Report to the Future Melbourne (Planning) Committee

Ministerial Planning Referral: TPMR-2019-9 539-557 Collins Street and 43-61 King Street, Melbourne

4 February 2020

DELEGATE REPORT MINISTERIAL PLANNING REFERRAL

Building Massing from Collins and King Street (Cox and Gensler dated November 2019)

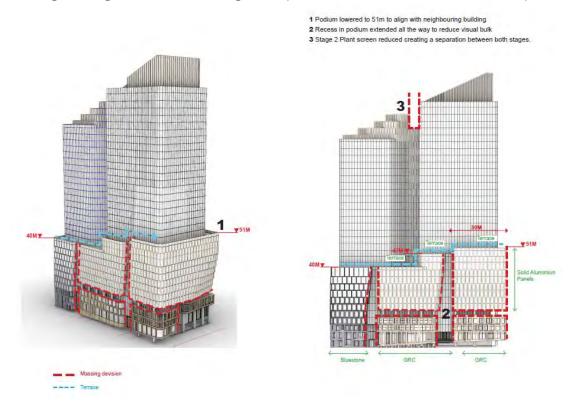
As shown in the building massing diagram above, on King Street, the street wall steps down from 50.6 metres to 47 metres then 40 metres at Flinders Lane. The 47 metre section of the King Street wall is not compliant with the modified requirement because this section is above 40 metres and does not form part of the street wall that defines the street corner. It is therefore recommended that this section be reduce in height to a maximum of 40 metres (i.e. maximum of AHD47.110).

- Reduce the height of the 45.35 metre section of street wall along King Street to a maximum of 40 metres (i.e. maximum of AHD47.110) excluding architectural features exempt under DDO10.
- b. Any changes as required as a result of the Façade Strategy in Condition3.
- c. Any additional changes as required as a result of the Road Safety Audit in Condition 14.
- d. Location(s) of onsite visitor bicycle spaces in accordance with Clause 52.34 of the Melbourne Planning Scheme.
- e. Further details of the design of Stage 1 southern façade to ensure the completed Stage 1 presents a high quality façade in the interim period between Stage 1 and Stage 2.

Western setback (boundary with 567 Collins Street) - 5 metres

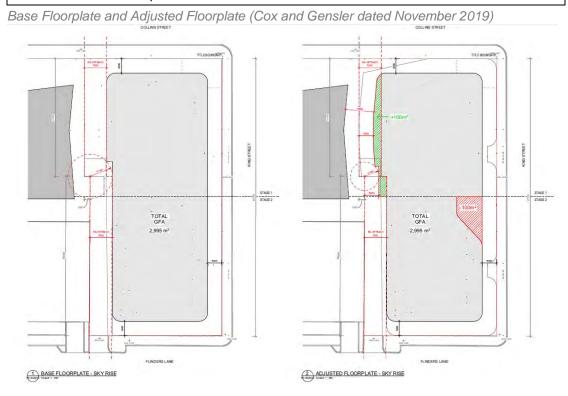
The application seeks an adjusted floorplate by providing a central indent to the tower form along the King Street elevation and reducing the side setbacks from 567 Collins Street to minimum of 5 metres instead of 7.70 metres.

The adjusted floorplate is required so that the proposal can provide a central indent. The central indent significantly reduces the visual dominance and bulk of the tower and ensures that the tower does not appear as a continuous wall along King Street.
